**Assembly Title 21 Committee
October 18, 2012**

**Review of Recommended Amendments
to the Provisionally Adopted Title 21
Follow-up Items**

Date: October 18, 2012
To: Assembly Title 21 Committee
From:  Jerry T. Weaver, Jr., Acting Director
Subject: Follow-up Items from the Assembly Title 21 Committee's Review of Proposed Amendments to the Provisionally Adopted Title 21

Figure 4.6. Building bulk (Floor-area-ratio) of existing properties in R-4 District, 2008

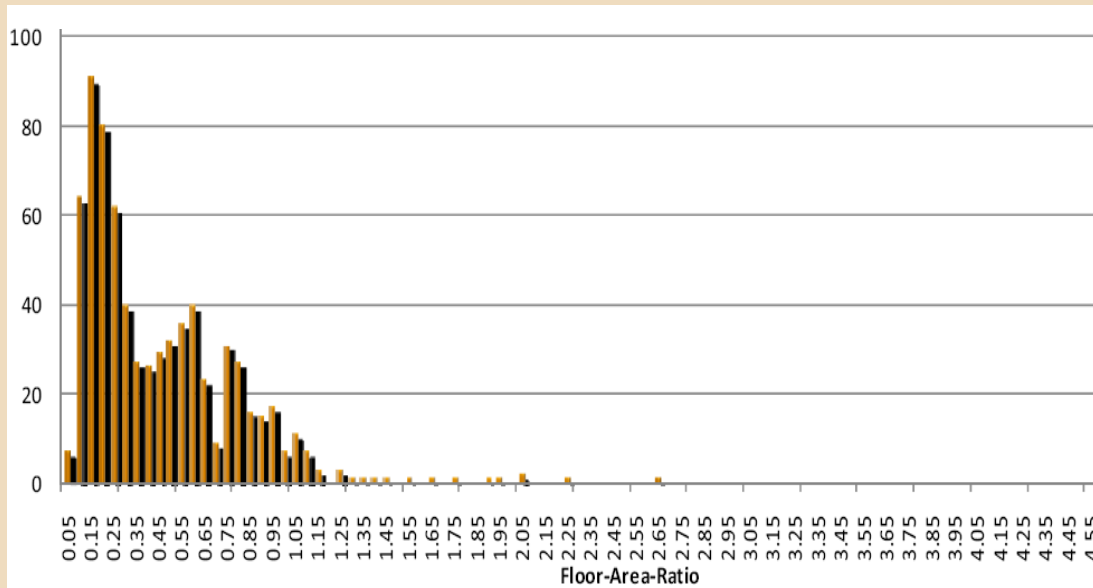
- The current bulk limit already allows more than what is typically built. Only a few dozen out of nearly 900 properties zoned R-4 achieve even 1 FAR, as shown in the graph on the next page.

- There are a limited number of sites near Midtown and Downtown, which have potential for residential development at a higher density. For these cases, the provisionally adopted R-4A District is available, allowing an FAR of up to 3.
- By comparison, the three highest density multifamily residential districts in the “West End” neighborhood in downtown Vancouver, B.C., the highest density city in the Pacific Northwest, allow a floor area ratio of 1 by-right, and up to a maximum of between 1.5, 2.2, and 2.75 FAR, respectively, provided that smaller lots less than 66-feet wide cannot exceed 1.5 FAR in any of these districts.

1. Retain the provisionally adopted maximum allowed bulk of 2.0 FAR with bonus features, and 1.0 FAR by-right for the R-4 District. If the Committee chooses to increase, limit that to 2.25 FAR and only for certain larger lots.
2. Retain the provisionally adopted maximum allowed bulk of 3.0 FAR with bonus features, and 1.0 FAR by-right for the R-4A District. If the Committee chooses to increase, limit that to 3.5 FAR and only for certain larger lots.

Current I-1 and I-2 Industrial Districts

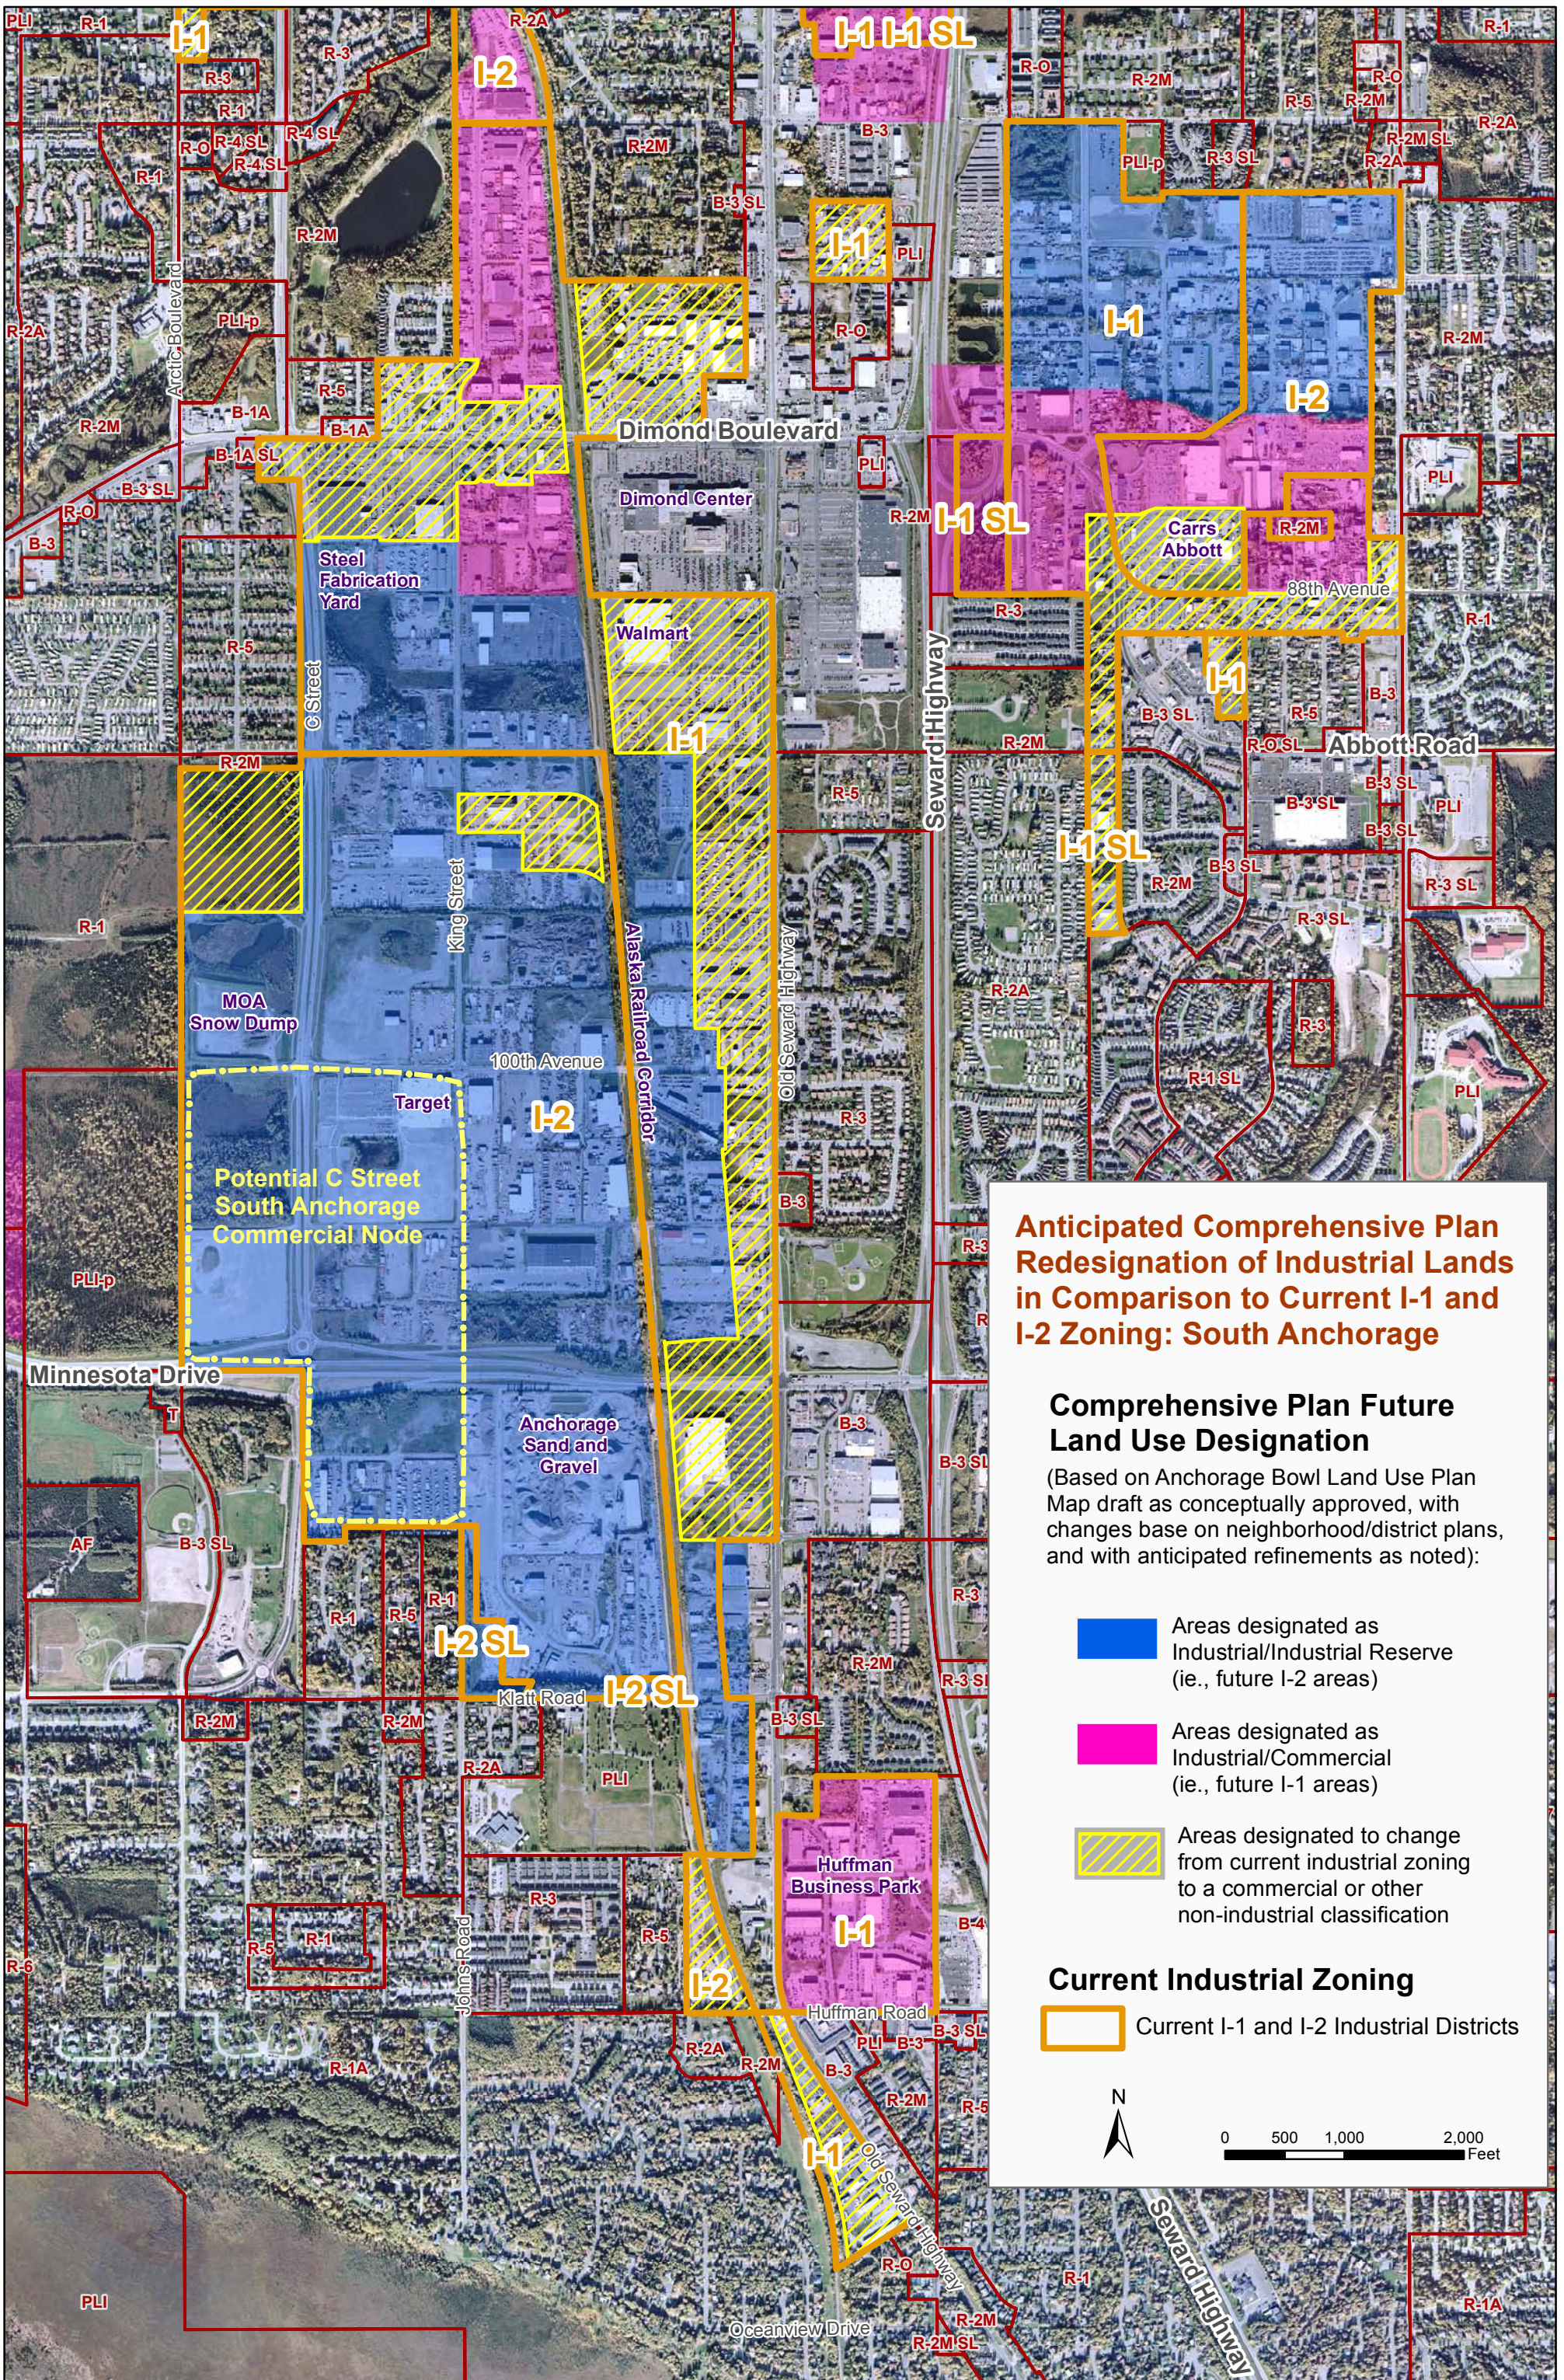
- (1) **Map Set:** The maps on the following pages show the location of I-1 and I-2 zoning in the Bowl, and generally the areas that the Anchorage Bowl Land Use Plan Map is most likely to redesignate to change from current industrial zoning to a commercial or other non-industrial classification, based on actual and emerging land use patterns.

Although the final revised Land Use Plan Map will be different in some areas, the yellow line hatch indicates generally that the future extent of industrially classified lands will be more limited and more focused on areas that are truly and appropriately industrial.

Typical Parking Facility Land Requirements

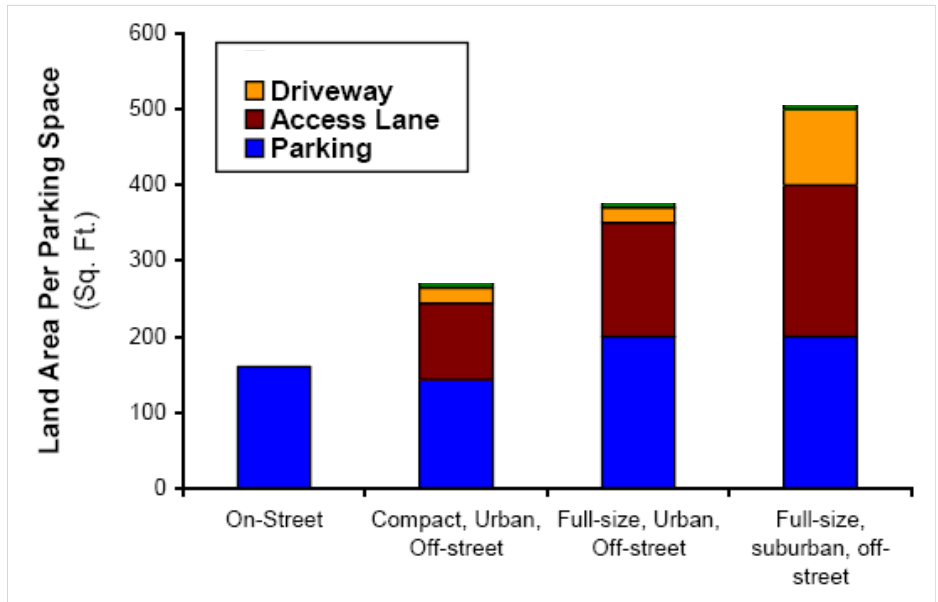
2. The number of parking spaces in a parking lot does not accurately determine what size of snow storage area it needs.

- Even among parking lots, the size of the paved area for a given number of parking spaces varies from one parking lot to the next, depending on facility design and configuration. See figure at right.
